QUESTION 2H.1 (DRL 2.7) Discuss the water flow patterns in the vicinity of the plant and their associated consequences on plant operations following a failure of the on-site water storage facilities.

QUESTION  
2H.2  
(DRL 2.8)

Docket 50-312  
Amendment No. 2  
April 15, 1968  
Appendix A to Question 2H.2

FIGURE 2H.2-3  
 EARTHQUAKE EPICENTERS  
 1942-1966 (200 MILE RADIUS)

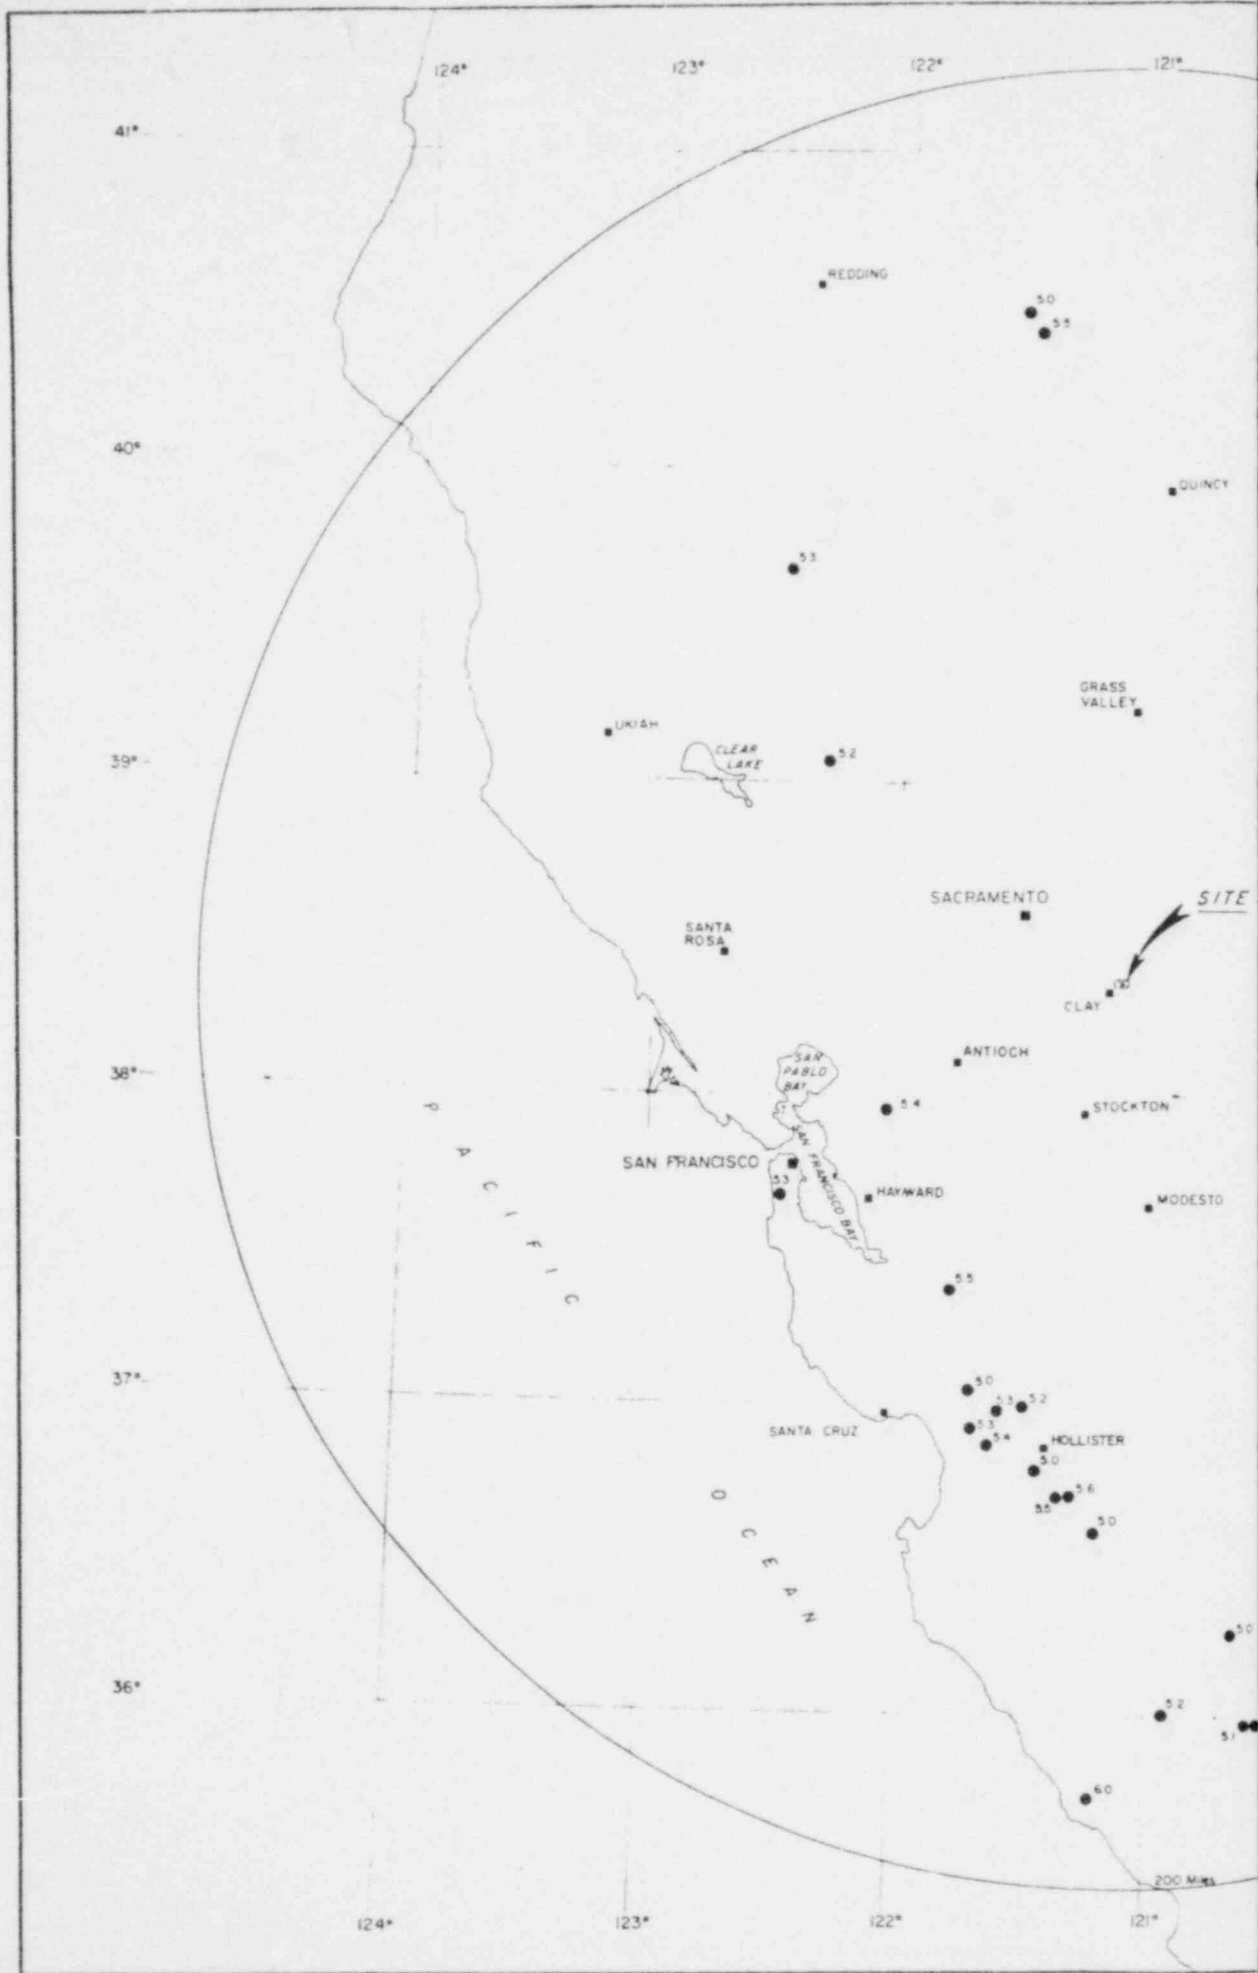
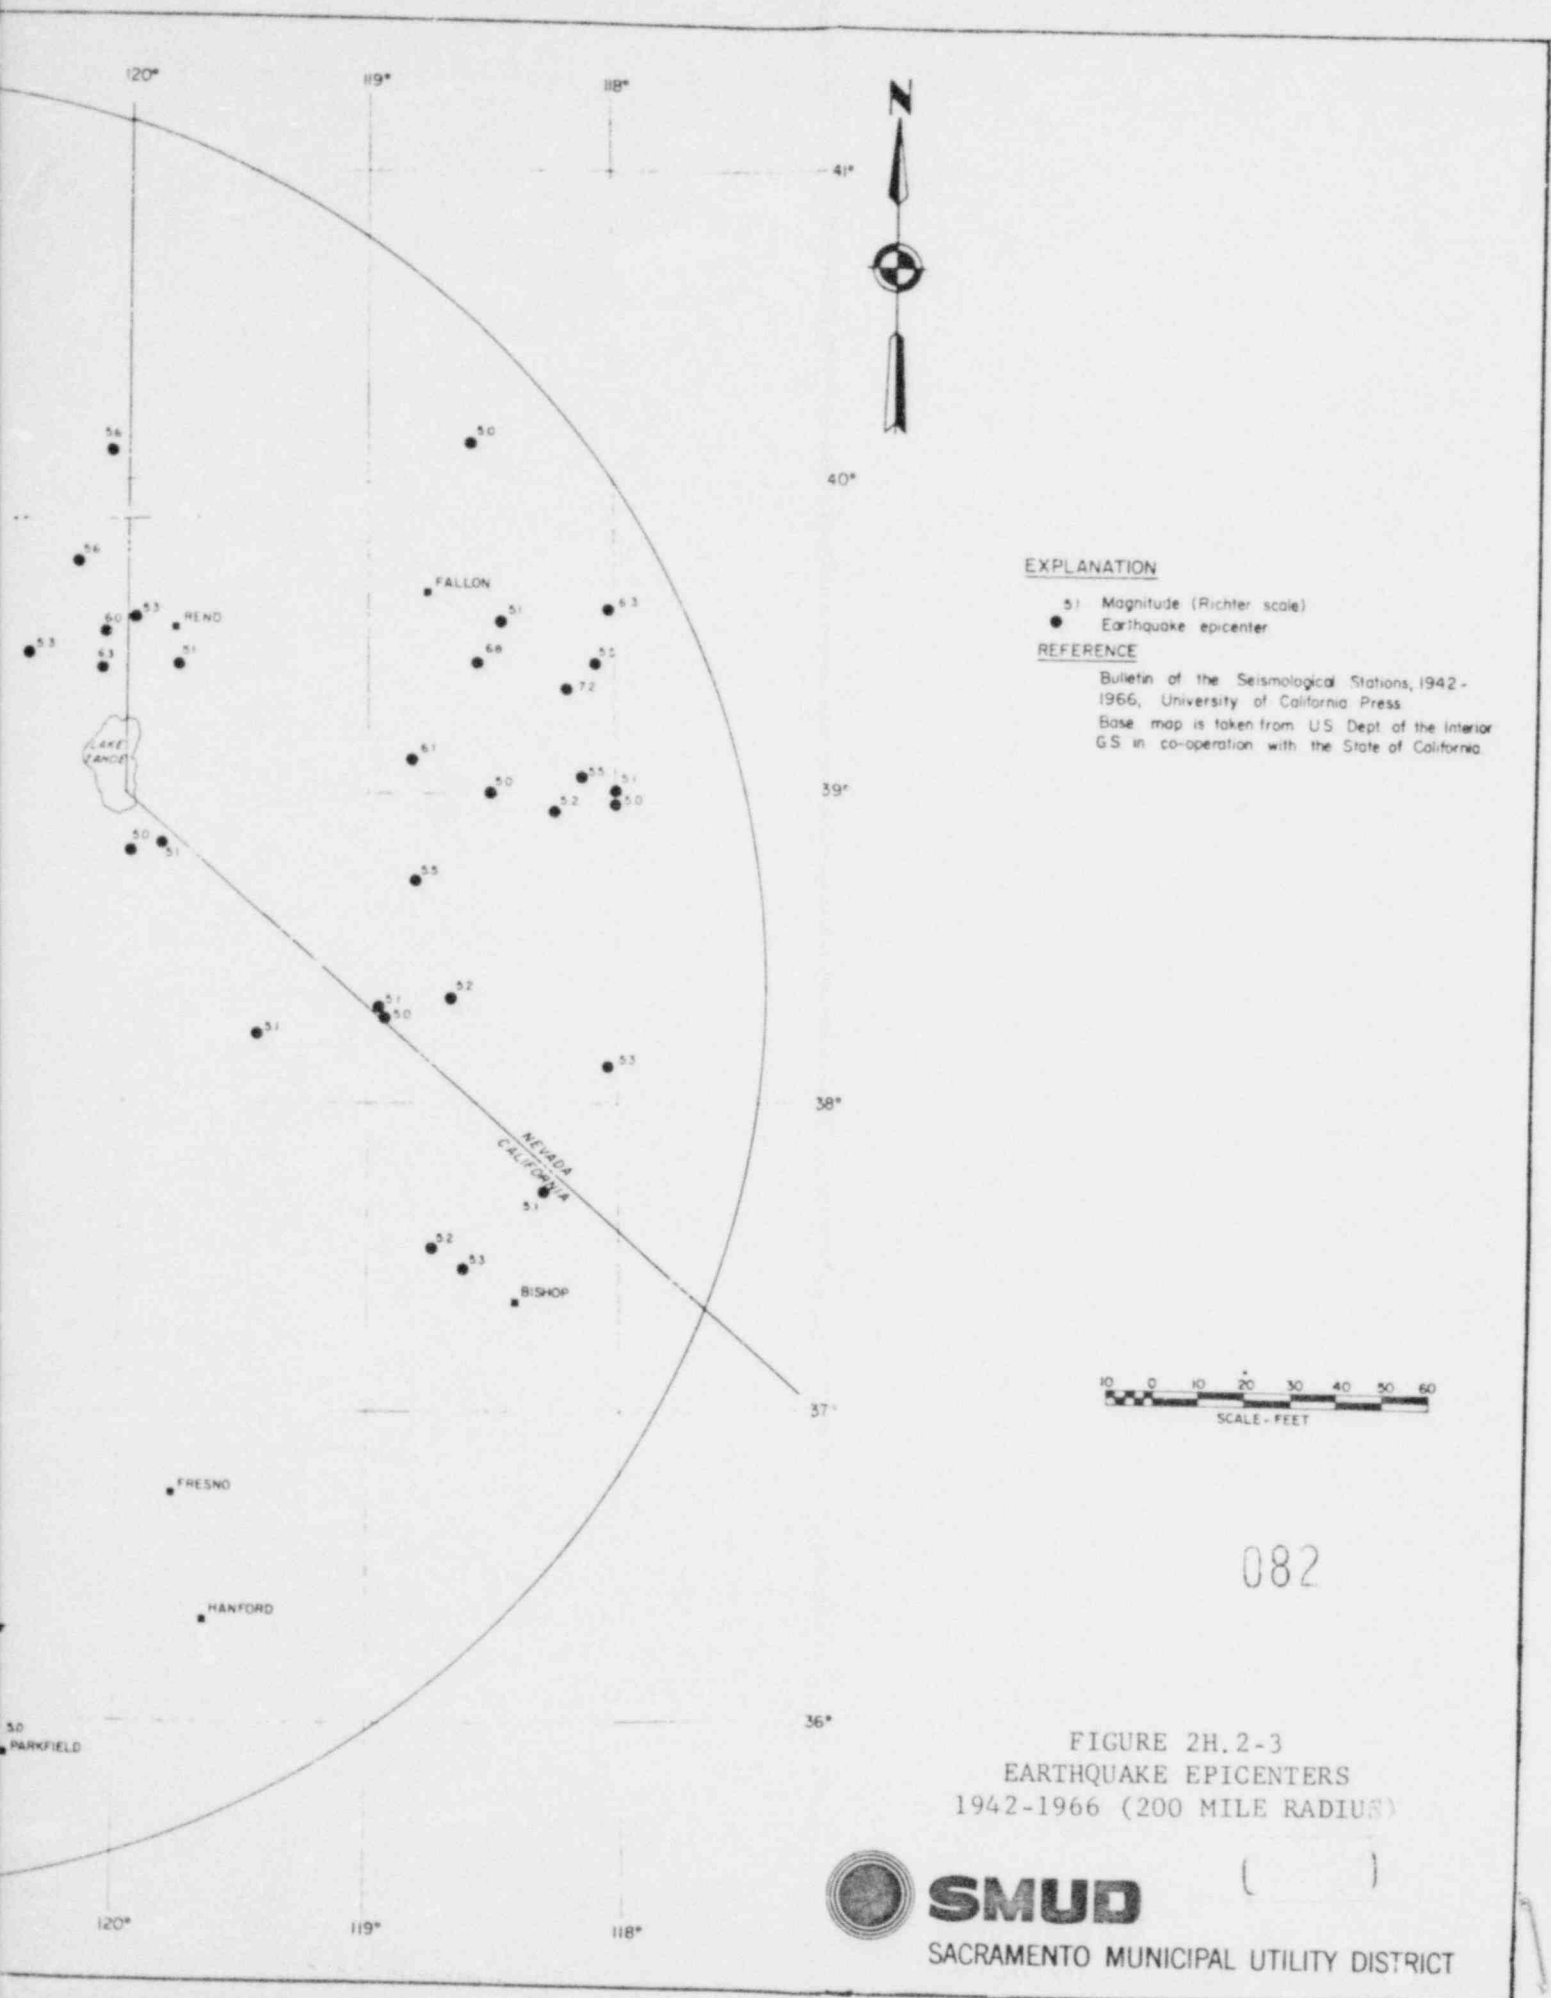
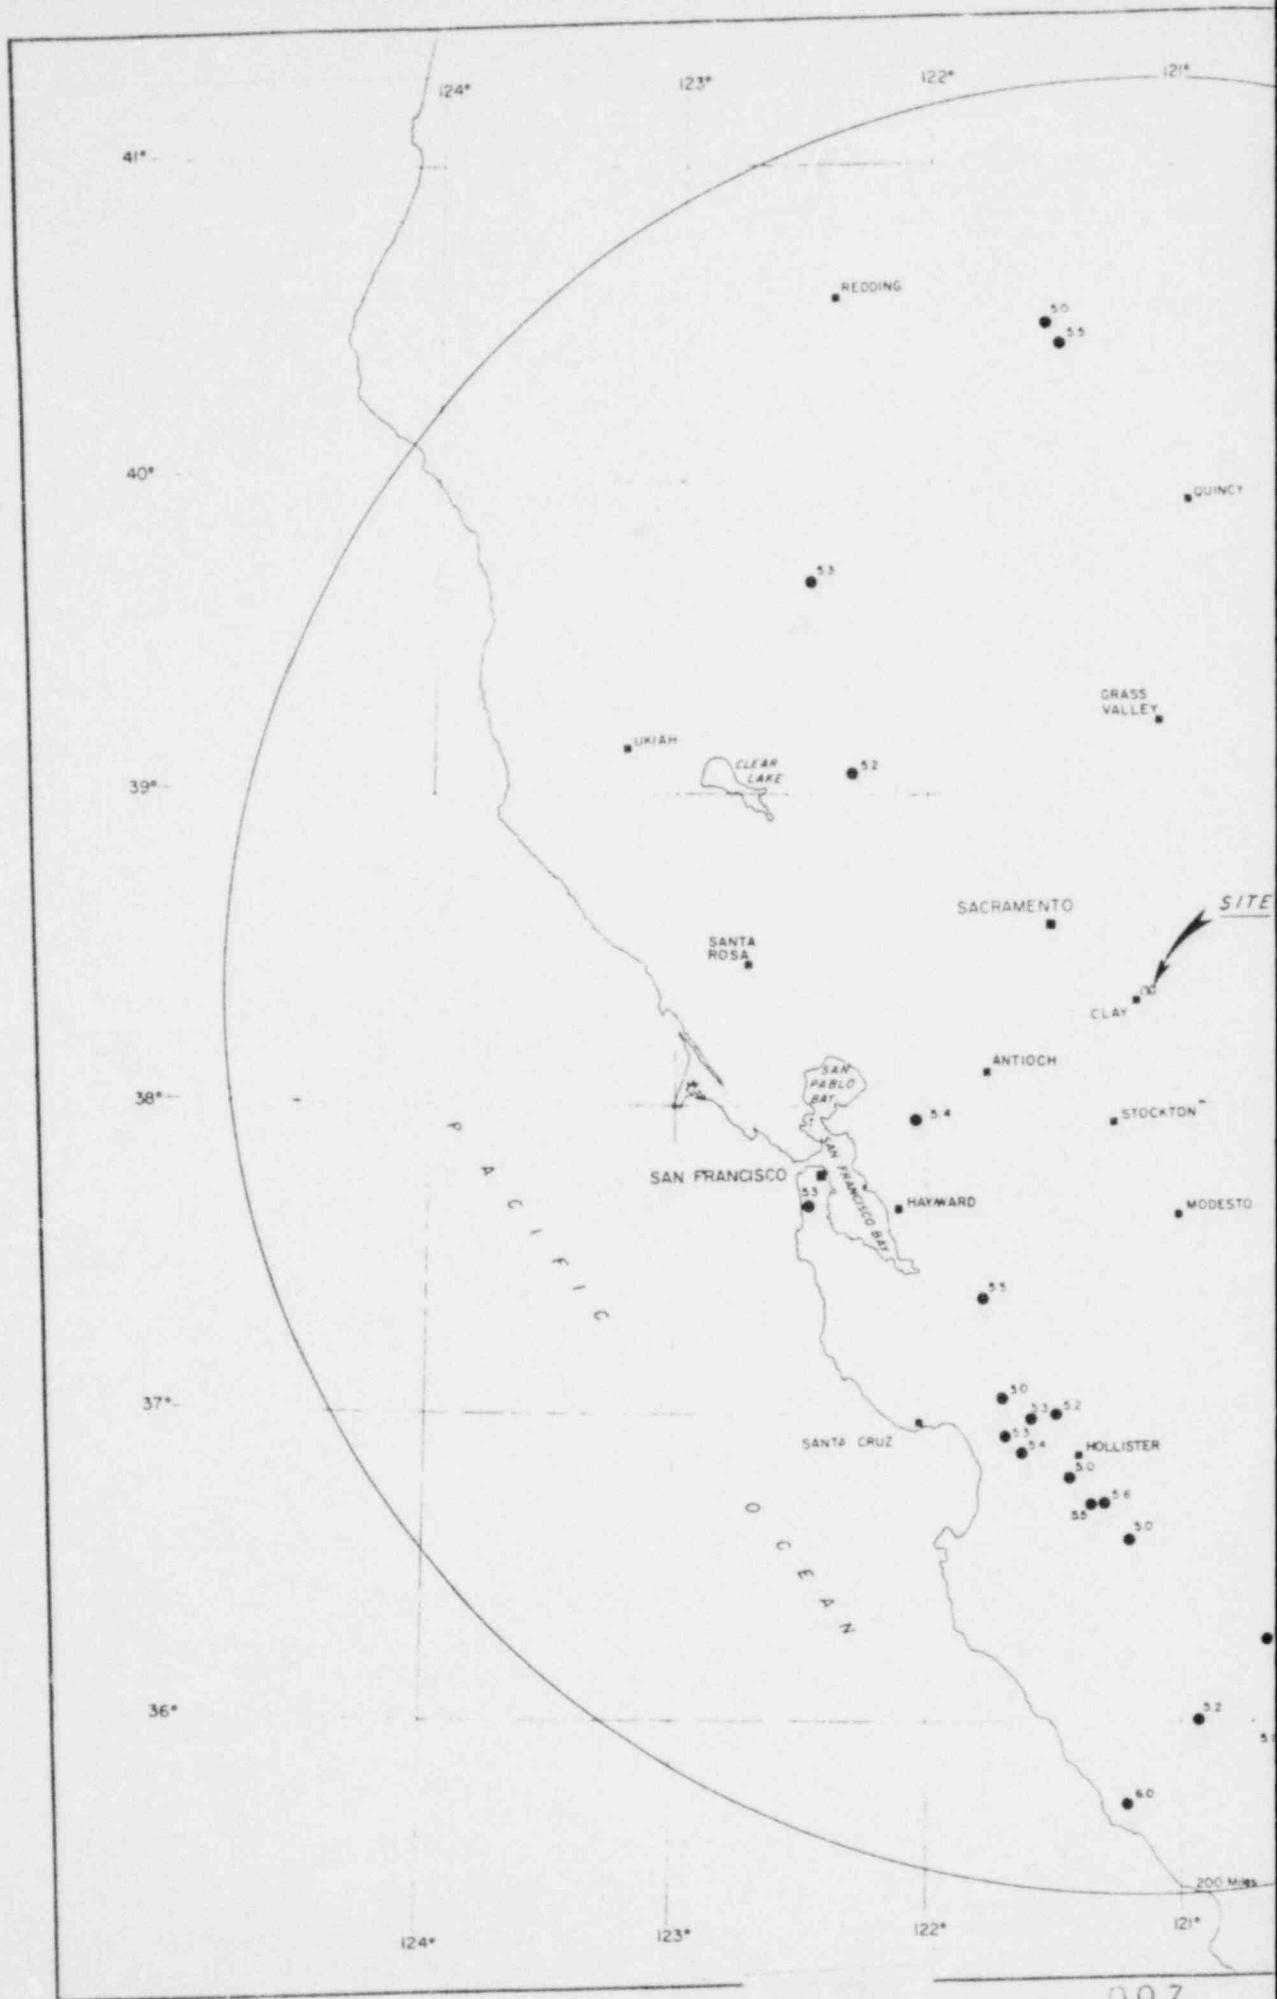
Provide a map of earthquake epicenters within a radius of 200 miles showing all earthquakes of intensity V or greater at the epicenter.

The epicenter map shows the magnitude of earthquakes actually recorded, while the non-instrumented seismic event map shows the highest intensity reported for any earthquake. It is considered that the 50 mile radius map presents a meaningful description of the site and adjacent area since varying geological conditions need not be evaluated. Similar maps for a 200 mile radius are shown in Figures 2H.2-3 and 4.
